We have amended the design of the proposals in response to public comments submitted. The comments raised the following issues.

1.0 Relationship to Ted Levy design

1.2 Proposals

5.1 Overlooking and privacy

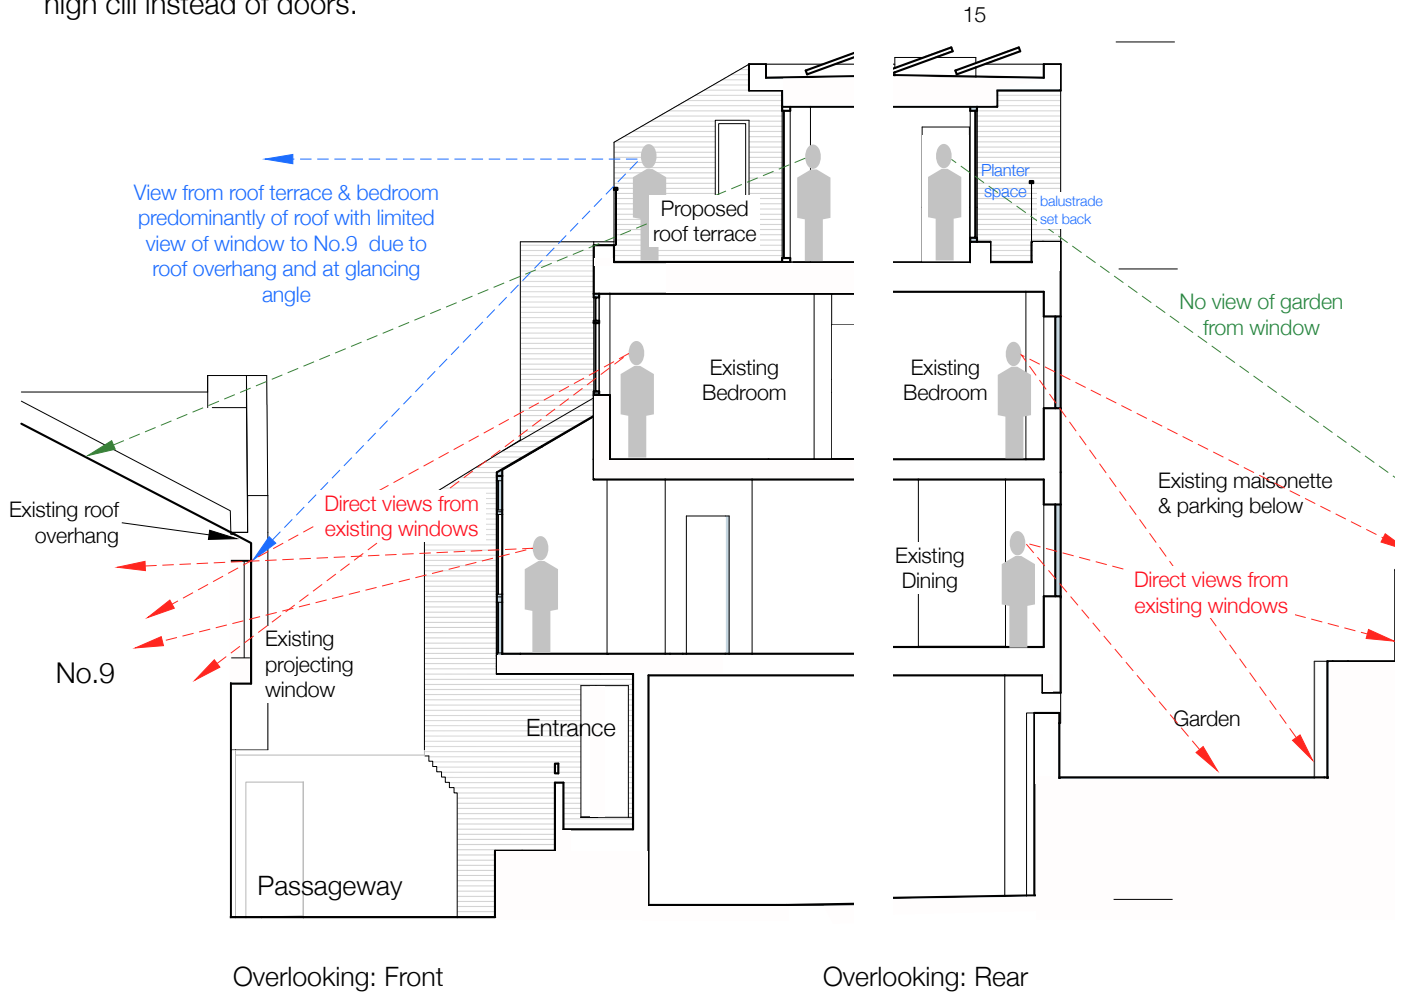
The existing houses at Nos. 19-25 are highly glazed to the south and already directly overlook the properties opposite and the central space of the mews Nos 19 and 22 already have set back roof terraces. No. 23 has an existing projecting balcony right on the corner, which overlooks the central space on its short side and also Nos. 7 & 8 at an angle. The existing projecting triangular balcony of No. 24 directly overlooks the central space and onto Nos. 7 & 8.

1. Existing balcony to No. 24
2. Existing balcony to No. 23
3. Proposed new balcony to No. 23

Windows in the houses to the south, Nos. 9 & 17 Maryon Mews, were carefully designed by Levy to minimise the effect of the extensive and direct overlooking from the existing south facing windows on 19-23. The proposed new balconies would have only a glancing view of the one window to No.9 which is set back under a deep eaves.

To the rear, the design has been amended to show a space for plants in the recess. The windows and railings have been set further back. Facing onto the noise of the railway, this space would not be occupied, but used to house plants and access for plant care would be by means of a window with a high cill instead of doors.
